Michael Krause
Manager, Planning and Rules
South Coast Air Quality Management District
21865 Copley Drive
Diamond Bar, CA 91765

**Re: SCAQMD Proposed Rule 1109.1 Working Group Meeting #8 Comments
Establishing Baseline Emissions to Calculate Emission Reductions
and Cost Effectiveness for Refinery Sector Equipment**

Source: SCAQMD, Rule 1109.1 WGM #8, June 27, 2019

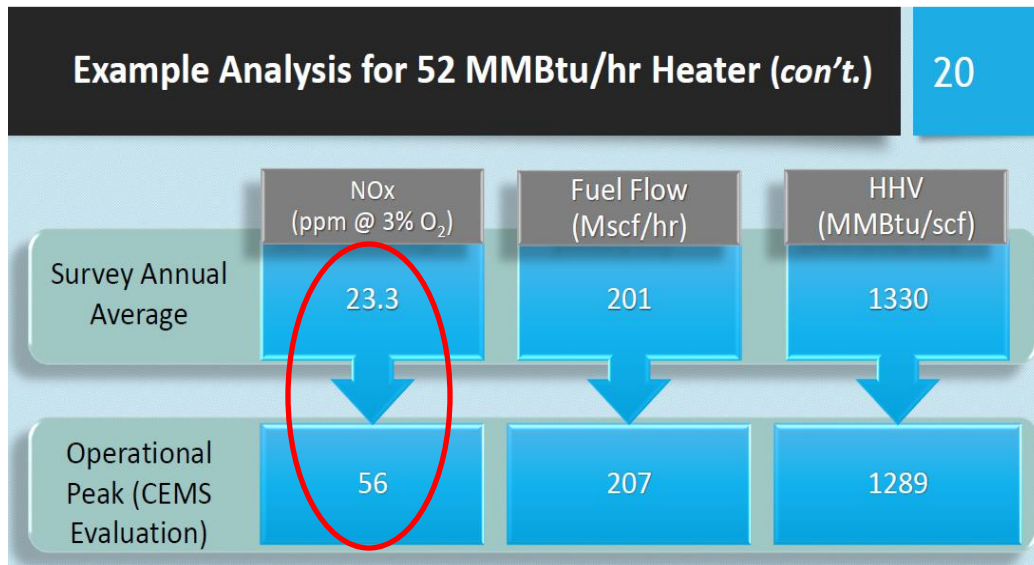
In the District's example (summarized on the below slide), the District assigned an Operational Peak value of 56 ppm for a refinery heater based on review of 1-hr average NO_x CEMS data obtained from a facility (all concentrations corrected to 3% O₂). That value, while indicative of peak short-term concentrations, is significantly higher than the reported annual average NO_x emissions concentration of 23.3 ppm.²

The Operational Peak approach would overstate baseline emissions in this example by more than 100 percent when compared to the actual reported annual emissions. While we do not currently have sufficient information to know whether baseline emissions for hundreds of other equipment subject to PR1109.1 would be overstated to that exact degree, we certainly know that a baseline emissions estimate using the Operational Peak approach will also be overstated relative to the actual annual emissions.

We recommend that the District rely on the annual average NO_x emissions data which was submitted by the facilities in order to characterize baseline emissions. These reported annual emissions levels are representative of the NO_x emissions which actually occurred during the baseline period. These data, in the aggregate, are also reflective of the effective market limitations imposed on the program by the NO_x RECLAIM cap.
